2. **Preliminary Plat- Panther West Additions (PP23-009)**  
**Petitioner:** Brent Dahlstrom of Panther Farms LLC, Owner; Brewer Civil LLC, Engineer  
**Previous discussion:** None  
**Recommendation:** *Introduction and Discussion*  
**P&Z Action:** *Discuss and continue to the next meeting*

TO: Planning & Zoning Commission
FROM: Jaydevsinh Atodaria (JD), AICP, City Planner I
Matthew Tolan, Civil Engineer II
DATE: March 21, 2024
SUBJECT: Preliminary Plat for Panther West Additions (PP23-009)

REQUEST: To approve Panther West Additions Preliminary Plat (PP23-009)
PETITIONER: Brent Dahlstrom, Owner; Brewer Civil LLC, Engineer
LOCATION: The property is located south of Greenhill Road and North of Aldrich Elementary School

# PRELIMINARY PLAT FOR PANTHER WEST ADDITIONS TO THE CITY OF CEDAR FALLS, BLACK HAWK COUNTY, IOWA

PP-2

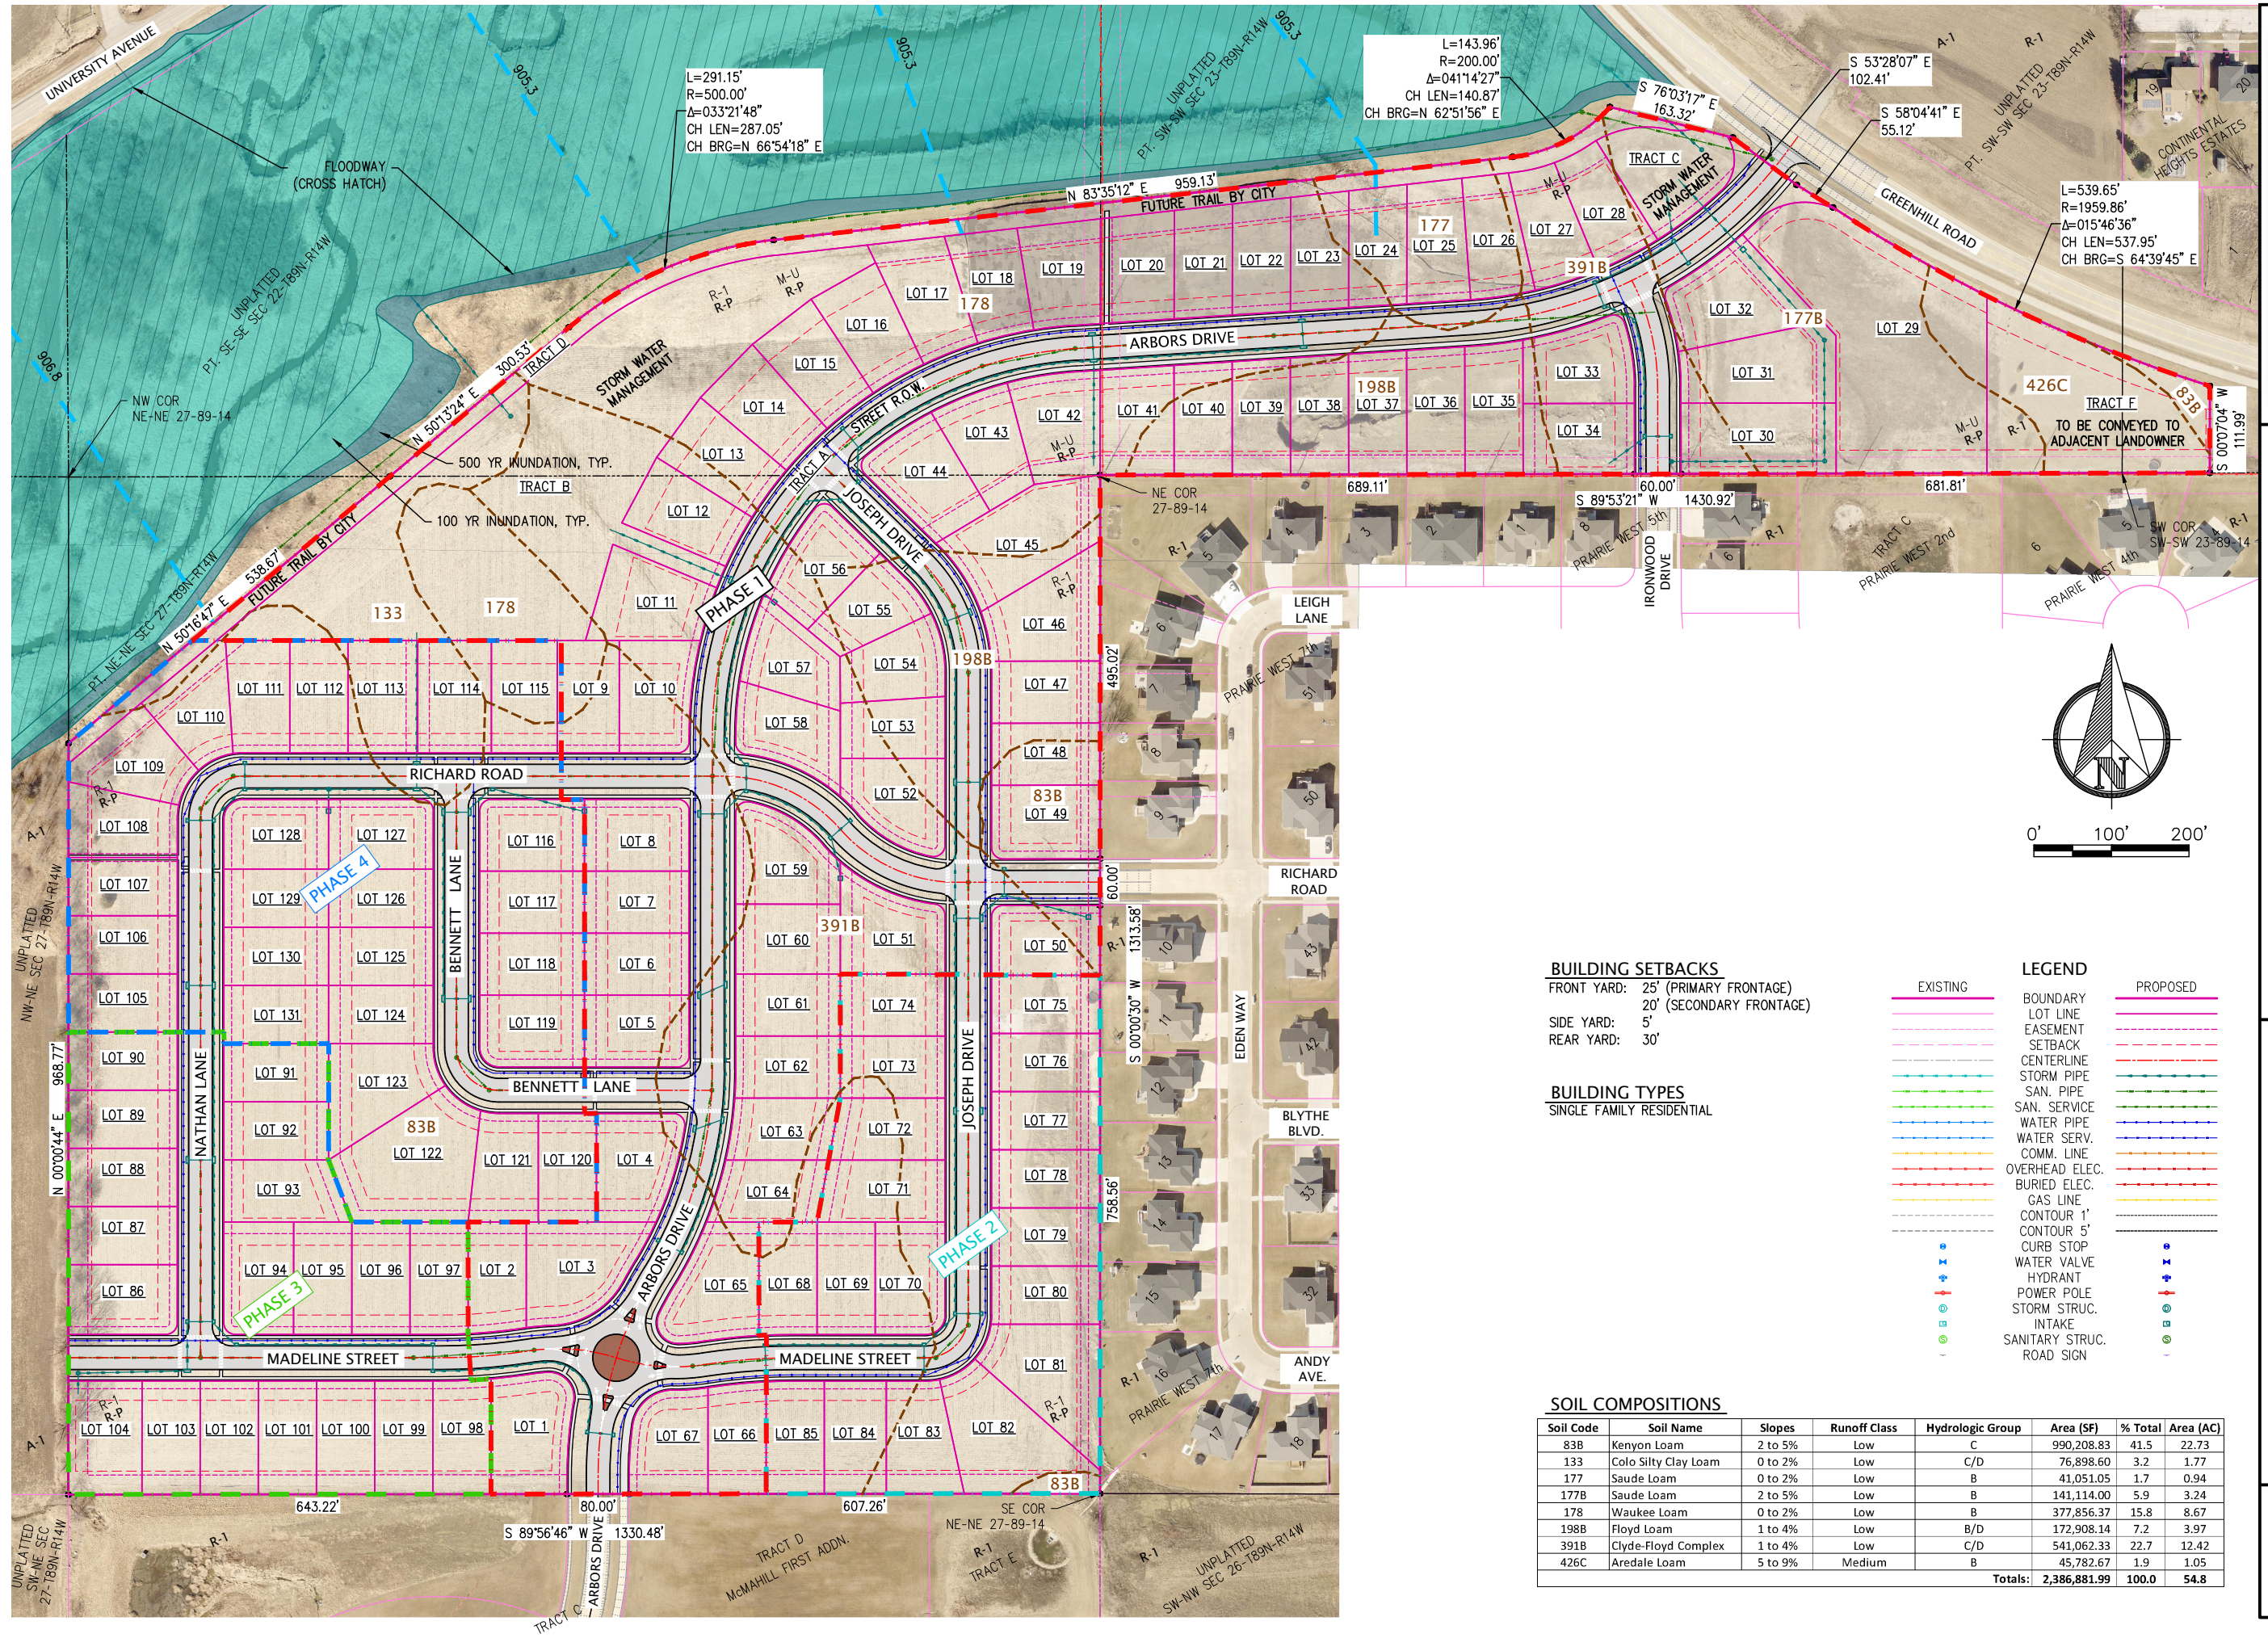
the plat for additional reference. However, staff notes that a label showing the perimeter setback line along the periphery of the proposed subdivision must be shown on sheet PP-2.

There are some minor label corrections to be done on the plat, including showing and labeling the perimeter setback on sheet PP-2.
